Approved for access by the Solid Waste Department.

ALBUQUERQUE DATA CENTER

SHEET TITLE:
SOLID WASTE PLAN

SHEET NO.:
C-602

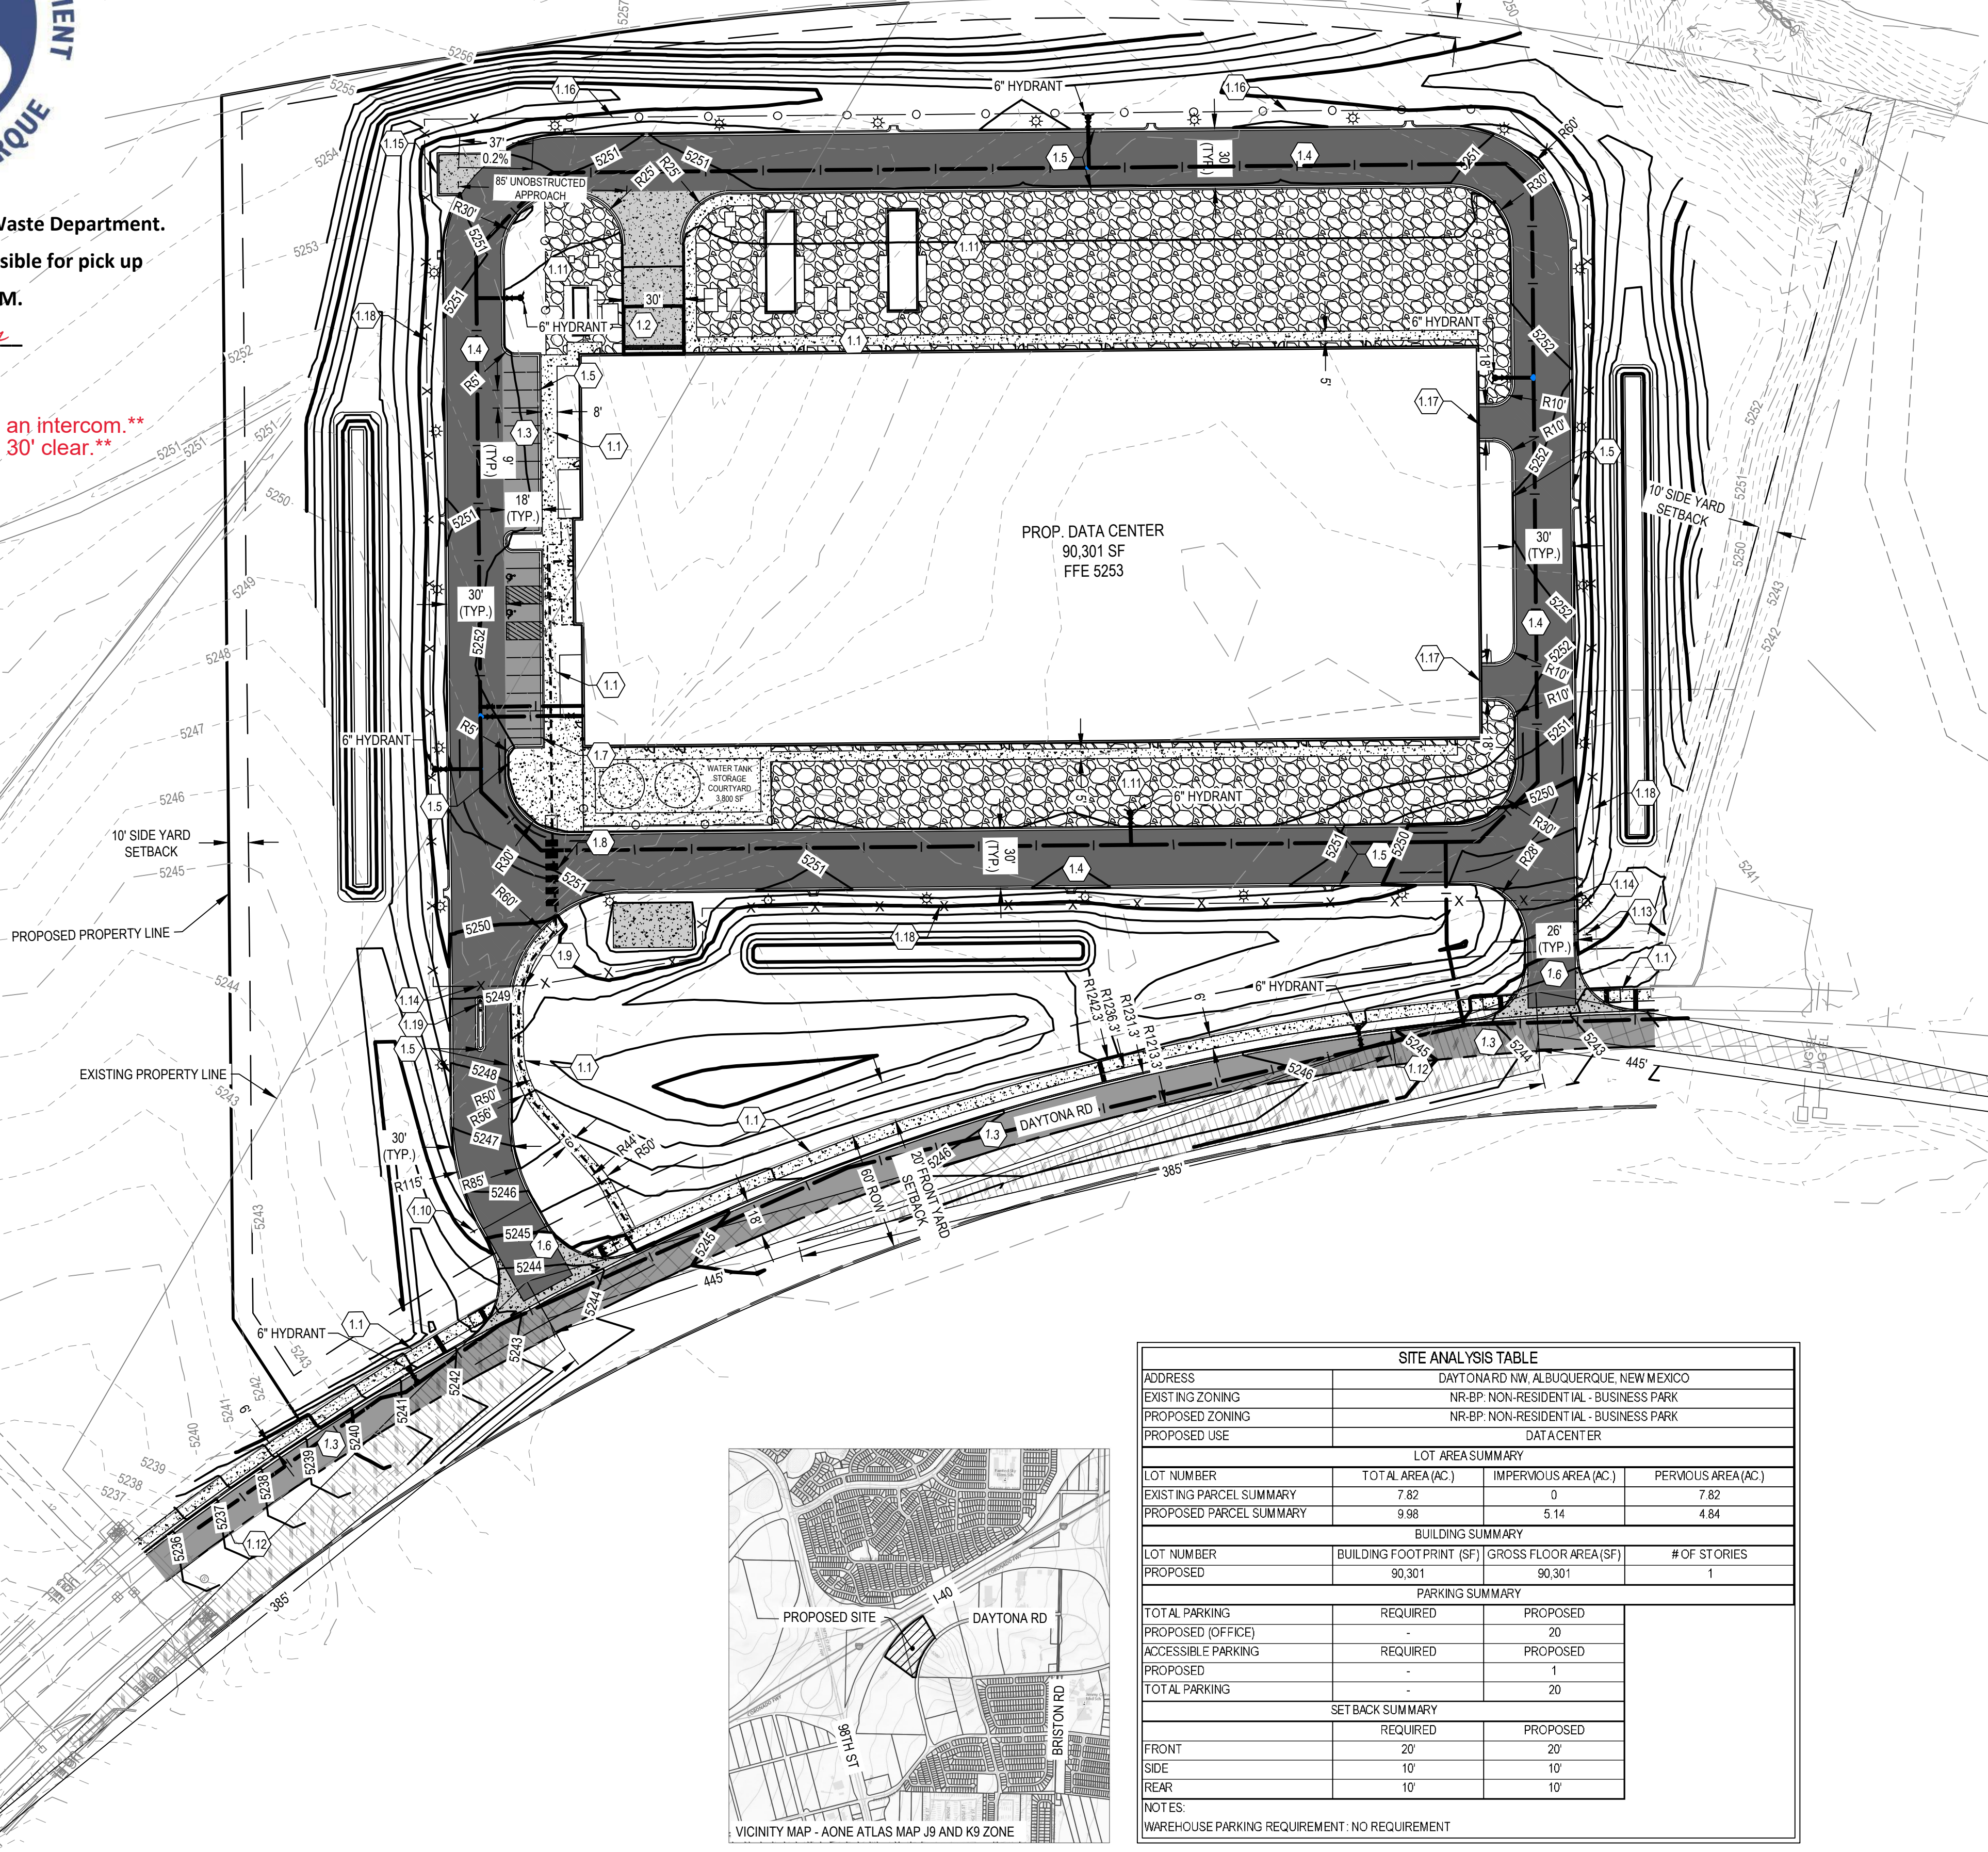
All containers must be made accessible for pick up

between the hours of 5AM and 8PM.

****Keycard access, security with an intercom.****

****Rolling access gate will open 30' clear.****
